# UNITED STATES PATENT AND TRADEMARK OFFICE

APPLICATION NO.	FILING DATE	FIRST NAMED INVENTOR	ATTORNEY DOCKET NO.	CONFIRMATION NO.
10/630,307	07/30/2003	Joel M. WasDyke	1001.1681101	9064
28075 7590 12/31/2009 CROMPTON, SEAGER & TUFTE, LLC 1221 NICOLLET AVENUE SUITE 800 MINNEAPOLIS, MN 55403-2420				
EXAMINER				
BUL VY Q				
ART UNIT		PAPER NUMBER		
3773				
MAIL DATE		DELIVERY MODE		
12/31/2009		PAPER

### Office Action Summary

## DETAILED ACTION

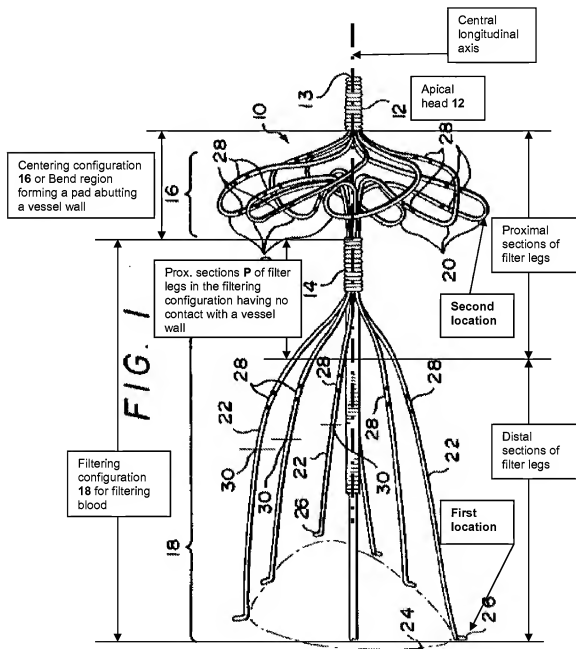
As to claims 13-17, 19-21, 24, 31, 33-34, Kleshinski-'162 (see reproduced and annotated Fig. 1 on next page; C 1, L 24-43; C 3, L 10-22; claims 1-4) discloses filter device 10 implanted in a blood vessel made of a shape memory/ nitinol/ super-elastic material having a transition temperature about a body temperature (98.6 F: C 1, L 39-42; claim 4) comprising:

1. apical head 12 having tip 13 and a central longitudinal axis passing tip 13;
2. generally symmetrical filter basket 18 (C 3, L 27-29) in a filter configuration having filter legs 22 with means for attachment/ hooks 26 (Fig. 1) attached to a blood vessel at a 1<sup>st</sup> location for filtering a blood flow;
3. generally symmetrical filter basket 16 (C 3: L 27-44) in a centering configuration having filter legs 20 with bends to form a bend region or a pad to abut the vessel wall (Fig. 1) at a 2<sup>nd</sup> location for filtering a blood flow and for centering the filter device inside the blood vessel.

Basket 16 and 18 are symmetrical about the central longitudinal axis passing through filter tip 13 (see C 3, L 27-29). Inherently, legs 20/22 are substantially disposed equidistantly

apart from the longitudinal axis of the filter device. Alternatively, it would have been obvious to one of ordinary skill in the art to arrange legs 20/22 at equidistant interval from the central longitudinal axis to keep the filter device aligned with a lumen of a blood vessel.

However, a proximal section of each leg 20/22 clearly show section configured to avoid contact with the vessel wall, for example, please see proximal section **P** of the filter configuration in the above reproduced and annotated F 1.

4. Applicant (Remarks, page 6/8, paper 12/09/2009) argued that " Additionally, the bend region of loops 20 forming a pad appear to curve circumferentially (as most easily seen in Figure 1 where loop 20 crosses over the wires as they enter the proximal end of coil 14) and do not appear to extend radially outward at equidistant intervals, as claimed.".

However, loops 20 extend radially outward from a location near apical head 12 or near the central longitudinal axis, and return back to a location near coil 14 or near the central longitudinal axis. As indicated above, Kleshinski discloses basket 16 is symmetrical, therefore the loops 20 must radially extend equidistantly from the central longitudinal axis as recited in the claims.
